NTD-NRC-94-4105
DCP/NRC0039
Docket No.: STN-52-003

SUBJECT: WESTINGHOUSE RESPONSES TO NRC REQUESTS FOR ADDITIONAL
INFORMATION ON THE AP600

NTD-NRC-94-4105
ATTACHMENT A
AP600 RAI RESPONSES
SUBMITTED APRIL 21, 1994

Figure 440.48-1
RCS and Ruptured Loop SG Pressure

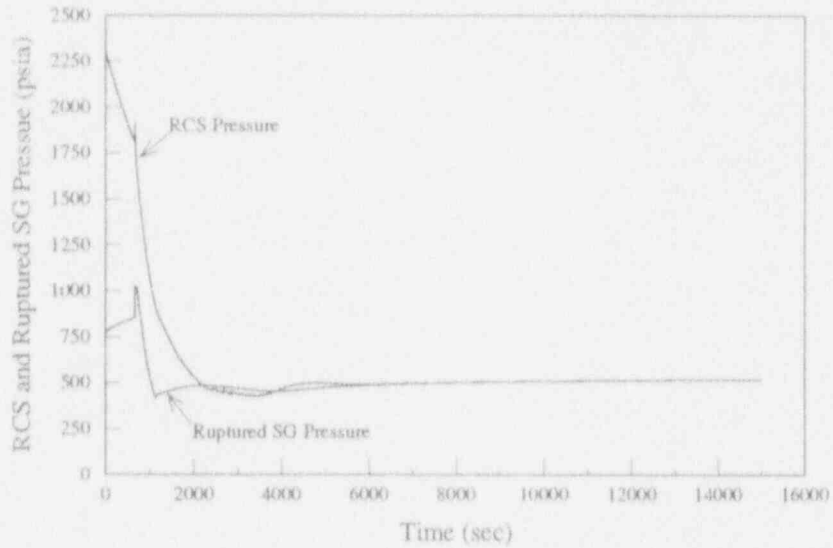
- a. The staff understands that the assumption of CVS flow tends to increase the primary-to-secondary break flow, thus maximizing inventory loss from the primary system. However, makeup from the CVS also delays the injection of makeup flow from the core makeup tanks (CMTs), and thus reduces the possibility that the CMTs will drain to the automatic depressurization system (ADS) first stage actuation setpoint. Present a new analysis assuming no onsite or offsite ac power availability to demonstrate that the AP600 is capable of being brought to a stable condition with (a) no operator action and (b) use of passive safety systems only.

- a. An analysis has been performed to demonstrate that the AP600 is capable of being brought to a stable condition with no operator action, using passive safety systems only and assuming no onsite or offsite power is available. Consistent with a complete loss of onsite/offsite power the CVS is not operational. This results in reduced margin to the low CMT level ADS setpoint. The analysis also incorporates other conservative analysis assumptions that result in reduced margin to the low CMT level ADS setpoint. These include the assumed failure of the ruptured steam generator PORV in the open position at reactor trip (to lower the RCS pressure so as to increase CMT injection flow), reduced steam condensation in the CMT (to increase the injection of CMT makeup flow), and reduced decay heat (to minimize RCS heatup and thus lower RCS pressure). This analysis incorporates PRHR initiation on a CMT actuation signal. The analysis demonstrates that there is still significant margin to the ADS setpoint, and that the passive safety systems are capable of bringing the AP600 to a stable condition without operator action. The sequence of events

for this analysis is presented in Table 440.48-1. Transient plots of primary pressure and ruptured SG secondary pressure and CMT volume, presented in Figures 440.48-1 and 440.48-2, show the plant response.

Figure 440.48-3
RCS Boron Concentration

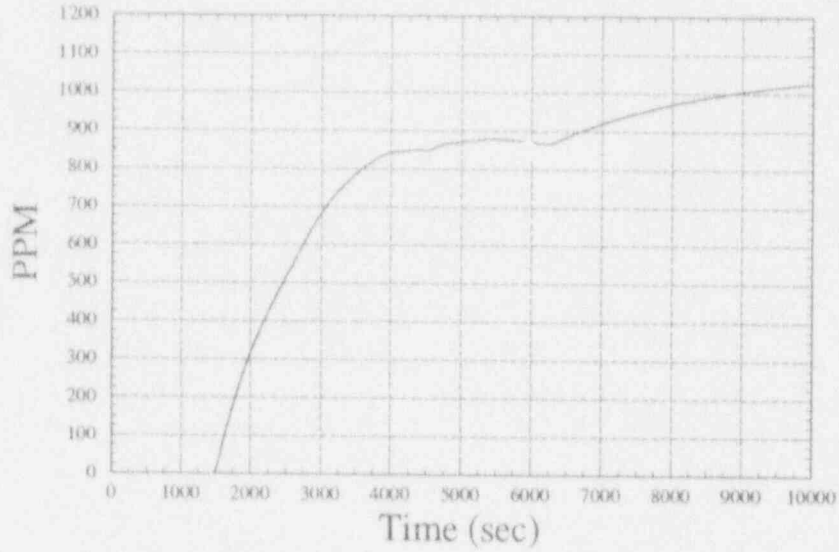
- b. Why does the AP600 design comply with the EPRI URD requirement for no steam generator relief valve actuation in the event of a single SGTR?
- c. The staff notes that Westinghouse's SGTR analysis requires flow from the secondary system back into the primary to stabilize the system near the end of the event. Describe how the effects of boron dilution on reactivity that can result from this backflow are accounted for in the analysis model.

- c. The SSAR SGTR analysis was performed to conservatively calculate the offsite radiological doses using the LOFTTR2 program. This analysis model does not track boron with the break flow. A calculation has been performed to determine the RCS boron concentration throughout the design basis SGTR transient utilizing a mass balance which accounts for the RCS boron addition and removal during the transient. The SGTR transient presented in Reference 440.48-1 was used for this calculation. Figure 440.48-3 presents the RCS boron concentration for the transient. This calculation demonstrates that the dilution due to back flow from the secondary system does not result in an appreciable reduction in RCS boron concentration. The initial reduction in the overall RCS boron concentration resulting from the reverse break flow is compensated for by boration from the CMT. Thus, the reverse break flow predicted to occur as the AP600 primary and secondary pressures stabilize near the end of the event does not present a reactivity concern.
